Application No.: 10/797,347

Docket No.: MOLLO 3.0-001

REMARKS

FIG. A

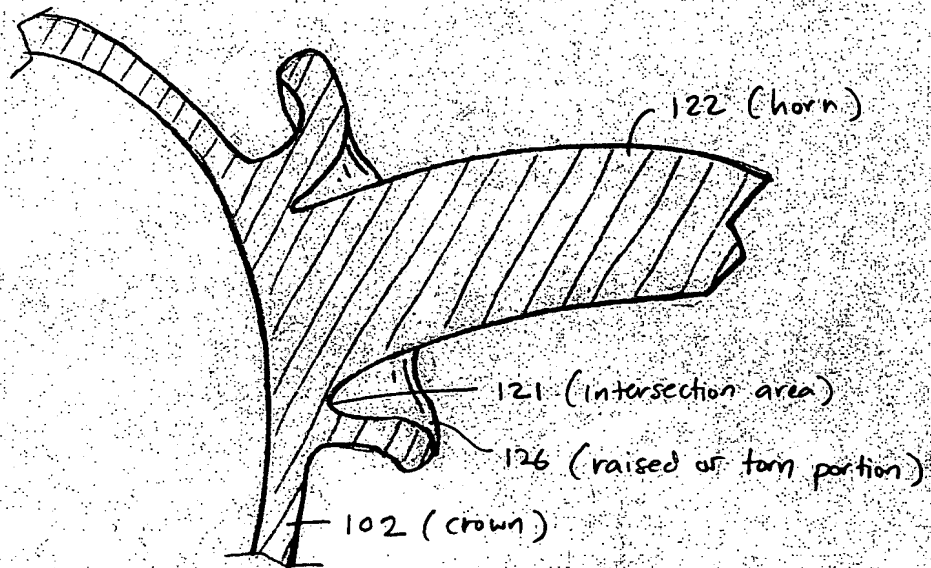
In paragraph 3 of the Official Action, the Examiner objected to the drawings under 37 C.F.R. § 1.83(a) for failing to depict each feature of the claimed invention. Specifically, the Examiner indicated that the intersection areas or attachment areas set forth in claims 2, 14-16, 21, 27, and 32 must be shown or the features cancelled from the claims.

As shown in FIG. A, the horn 122 extends from the crown 102 from an intersection area 121. The intersection area is formed at the intersection of the horn and the crown. The crown also includes a raised or torn portion 126 which extends above the intersection area. In FIG. B, the exterior surface 124 of the crown has been enhanced for clarity. It is clear in FIG. B that the exterior surface of the crown and the horn meet at an intersection area.

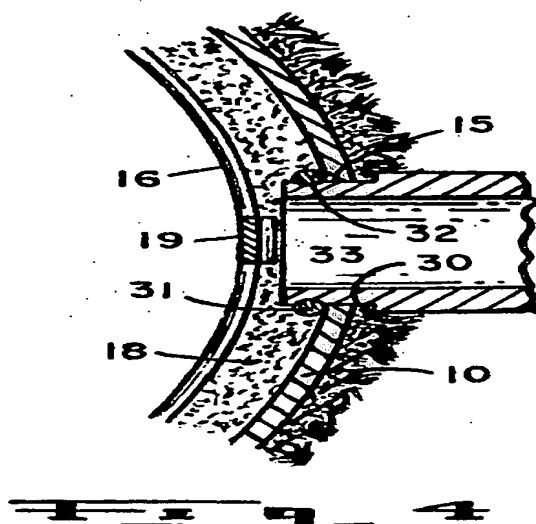
The Examiner also notes that the intersection/attachment area may not be different from such area taught by the *Fineberg* reference (U.S. Patent No. 3,381,308). As a comparison, FIG. 4 of the *Fineberg* reference is depicted below.

As shown in FIG. 4 of *Fineberg*, *Fineberg* discloses a crown 10 (col. 2 l. 36, "shell 10.") and a horn, which is the horizontally oriented shaft shown in FIG. 4 (col. 2 ll. 42-43, "horns 28 and 29"). In *Fineberg*, the horn 28, 29 does intersect with the crown 10. However, in order to compare the *Fineberg* reference with the present invention, one must look to the present claims.

In claim 2, a portion of the exterior surface of the crown must be raised above the intersection area to evince an association between the secondary element in the manner in which it extends from the crown. In *Fineberg*, no portion of the crown

is raised above the intersection area. Rather, the crown 10 continues along a single arcuate path - from which it does not deviate - until the crown meets the horn 29.¹
